PCJ OIL PRESSURE SENSOR REPLACEMENT Prevost vehicles

On the vehicles affected by this bulletin, the PCJ oil pressure sensor has to be replaced with an updated pressure sensor to avoid erroneous low oil pressure diagnostic codes.

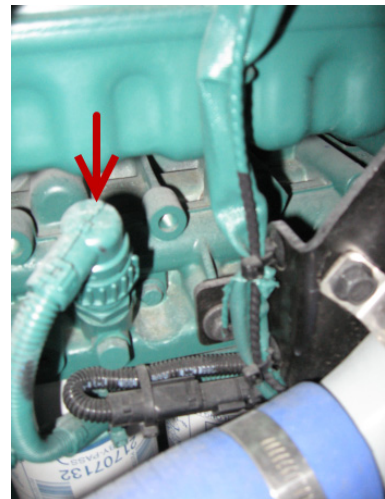
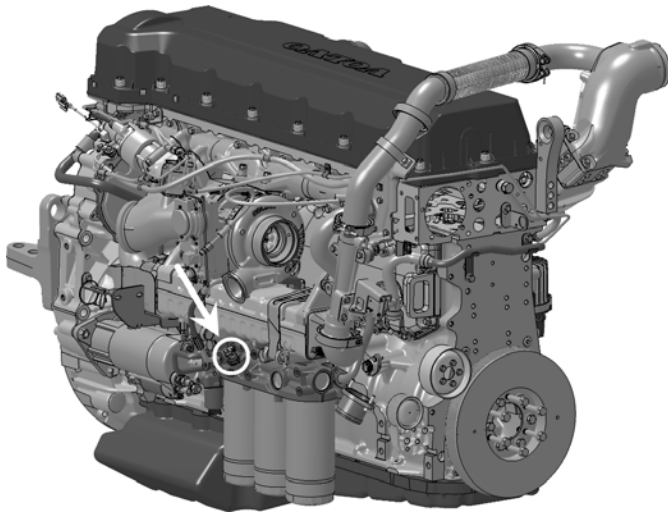
- 1) Disconnect the PCJ sensor connector rotating the knurled collar counterclockwise. See the image below to locate the sensor.

- 2) Unscrew the sensor from the oil filter housing.
- 3) Clean out the electrical connector pins and sensor mounting surface with contact cleaner.
- 4) Install the new PCJ sensor (p/n 21634021). Torque: 18.5 ± 2 ft-lb.
- 5) Reinstall the connector and rotate clockwise to lock.
